<b>Notice of Allowability</b>	<b>Application No.</b>	<b>Applicant(s)</b>	
	10/615,908	HISANO ET AL.	
	<b>Examiner</b>	<b>Art Unit</b>	
	Ingrid Wright	2835

**DETAILED ACTION**

***Allowable Subject Matter***

FIG. 2

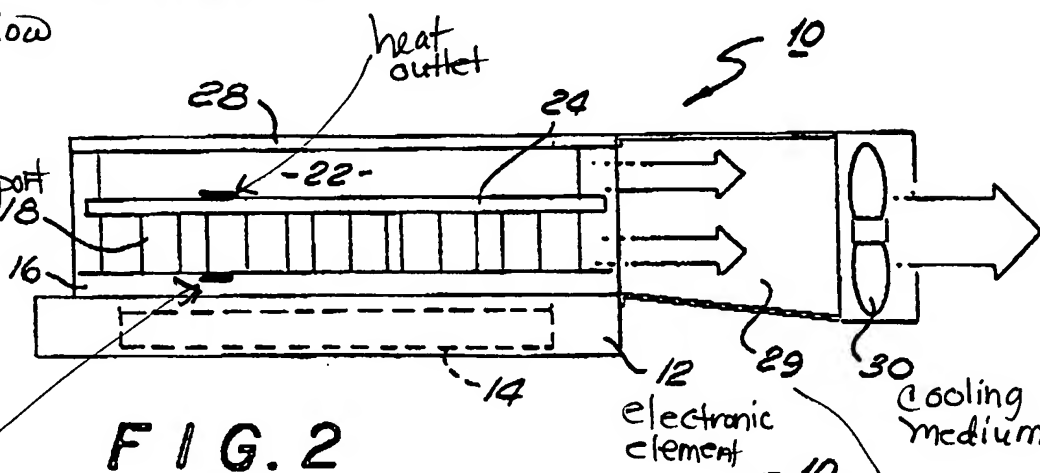
Note: See attached fig. 2 of Ishida et al. & fig. 2 of Chu et al. for elements representing claimed limitations in the instant application.

**US 6173576 to Ishida et al.** is considered to be a close reference to the instant application, Ishida et al. disclosed an electronic element (12) and a second flow channel (20), in a flow of cooling medium (30), an active heat transport element (18), a heat intake portion and a heat outlet portion (see, notation on attached fig. 2 of Ishida et al.). Heat is conducted from the heat intake portion to the heat outlet portion and the heat outlet portion is thermally connected with the second flow channel (20), but Ishida et al. lacks the heat intake portion being upstream of the cooling portion and thermally connected with a first flow channel so as to as to conduct heat from the cooling medium before the cooling medium arrives at the cooling portion.

fig. 2

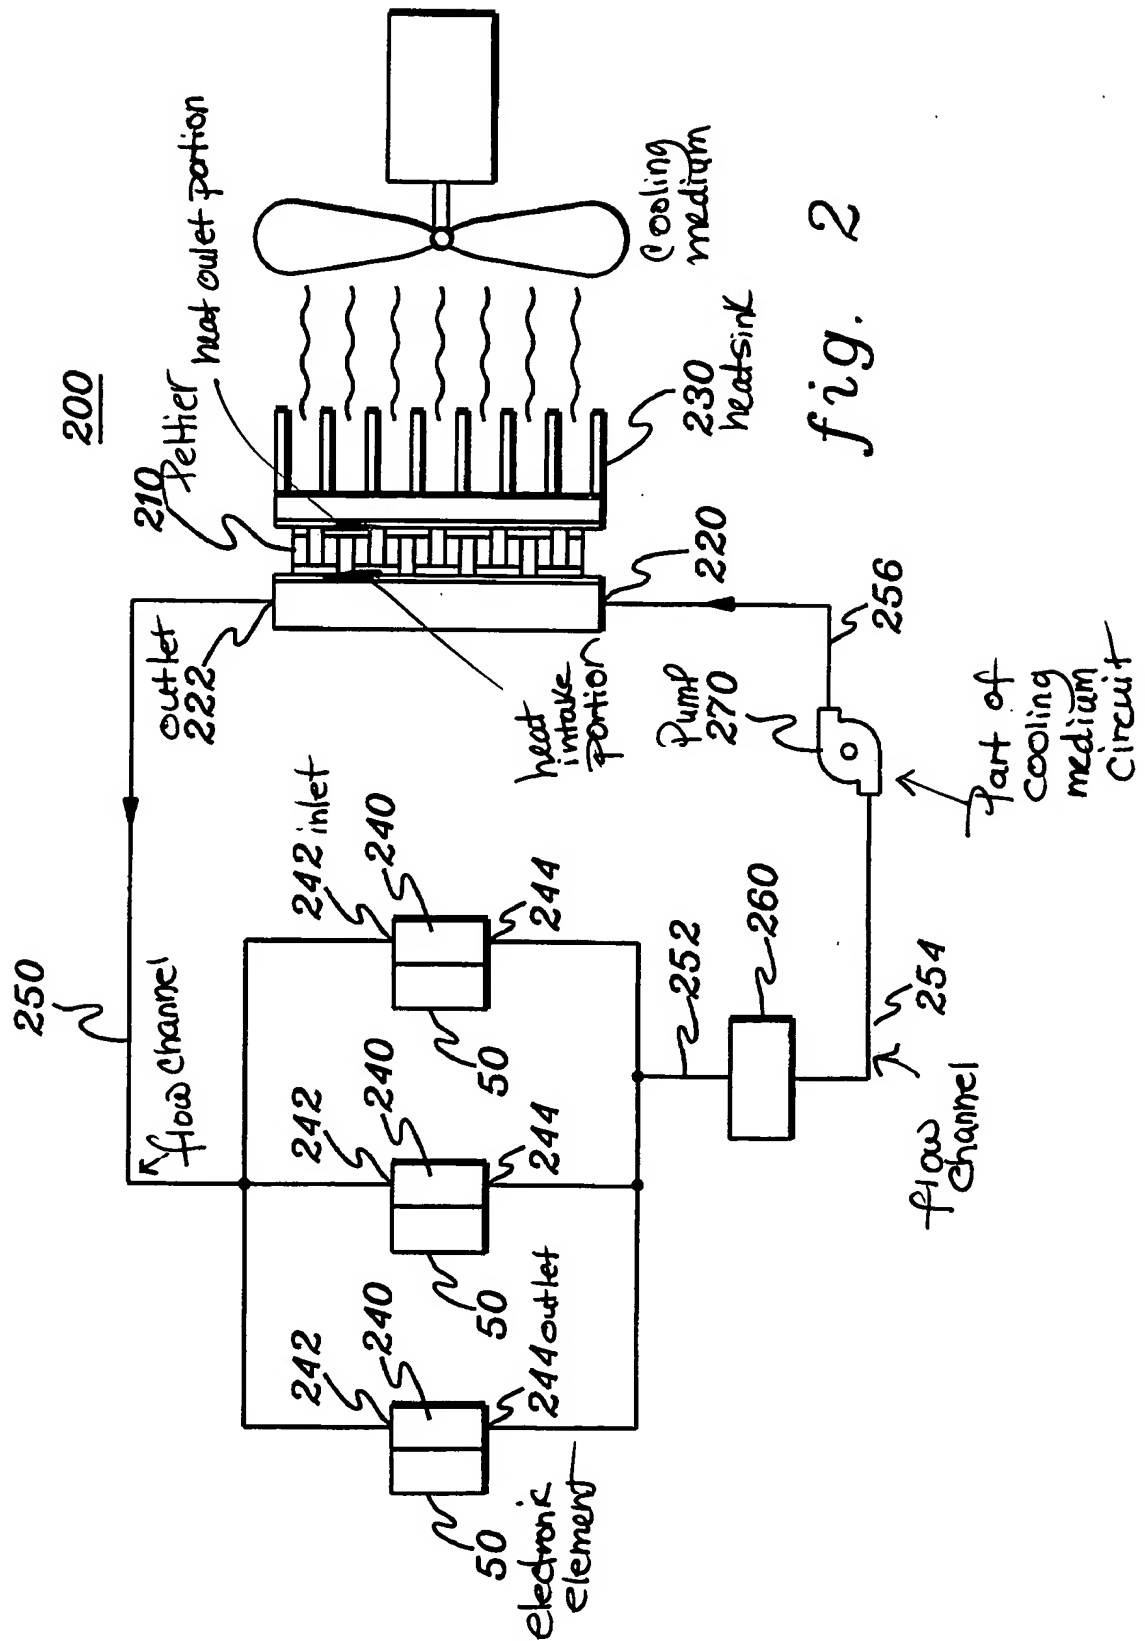
**US 20030188538 A1 to Chu et al.** is also considered a close reference to the instant application, Chu et al. disclosed an electronic element (50) and two flow channels (see, notation on attached fig. 2 of Chu et al.) in the flow of a cooling medium (see, notation on attached fig. 2 of Chu et al.), an active heat transport element (210) and a heat intake portion (see, notation on attached fig. 2 of Chu et al.). The active heat transport element (210) conducts heat transferred from the cooling liquid to a heat transfer plate (220), and heat is further pumped from the heat transfer plate (220) to an air-cooled heat sink (230) through the active heat transport element (210) (see, col. 3, par. 0040 of Chu et al.), but Chu et al. lacks heat conducted from the cooling medium before the cooling medium arrives at the cooling portion.
